**Proposed East Elevation - Cross sectional view**

S73 MINOR MATERIAL AMENDMENTS

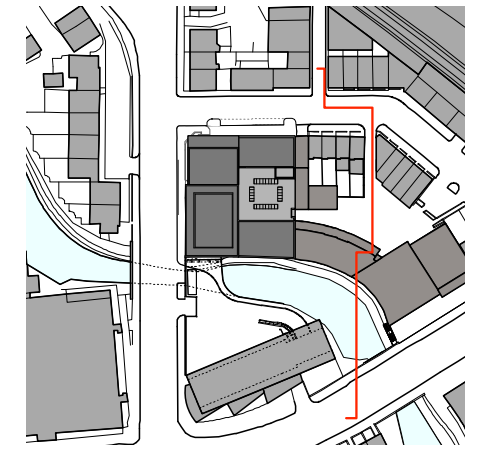
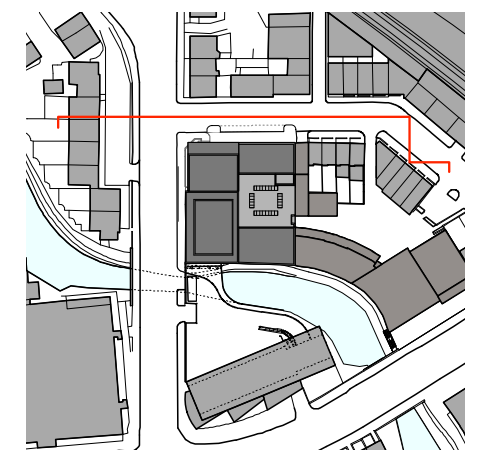
- 3.GENERAL:  
 -East elevation updated to match A215-Rev.F  
 -North elevation updated to match A216-Rev.F

- East elevation updated to match A215-Rev.G  
 -North elevation updated to match A216-Rev.G

- East elevation updated to match A215-Rev.H  
 -North elevation updated to match A216-Rev.H

**Proposed West Elevation**  
(Camden Street View)

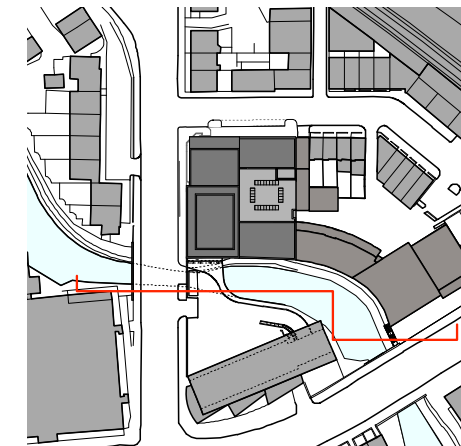
- 1.RESIDENTIAL:
- R.5) Block C refuse store and cycle lift repositioned, staircases amended, door added.
- R.12) Stair access to Block B roof omitted, lift overrun not required and omitted, AOV repositioned.
- R.13) Block B roof layout revised, communal terrace changed to private terrace.

- 1.RESIDENTIAL:
- R.5) Block C entrance repositioned, entrance hall amended, staircase amended, refuse store repositioned.

**Proposed South Elevation**  
(Canal View)

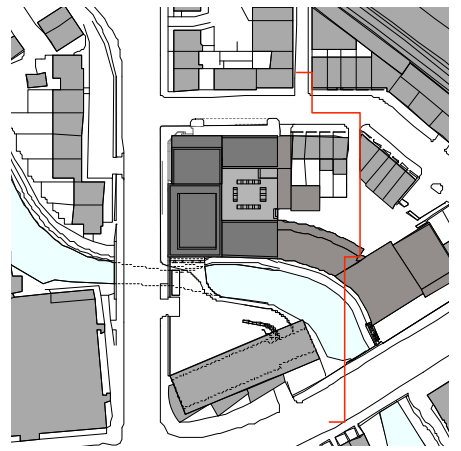
1.RESIDENTIAL:  
R.5) Block C refuse store and cycle lift repositioned, staircases amended, panel added.

1.RESIDENTIAL:  
R.5) Block C entrance repositioned, entrance hall amended, staircase amended, refuse store repositioned.

**Proposed East Elevation**  
 (Regent Canalside View)

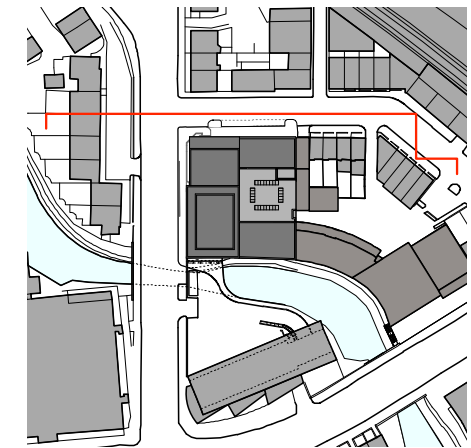
**Rev.G 14/05/2017:**  
 1.RESIDENTIAL:  
 R.11) Lift overrun over Core A roof indicated.  
 R.12) Stair access to Block B roof omitted, lift overrun not required and omitted, AOV repositioned.  
 R.13) Block B roof layout revised, communal terrace changed to private terrace.

**Rev.H 21/06/2017:**  
 1.RESIDENTIAL:  
 R.8) Lift overrun on the roof above the third floor of Block A not required and omitted.
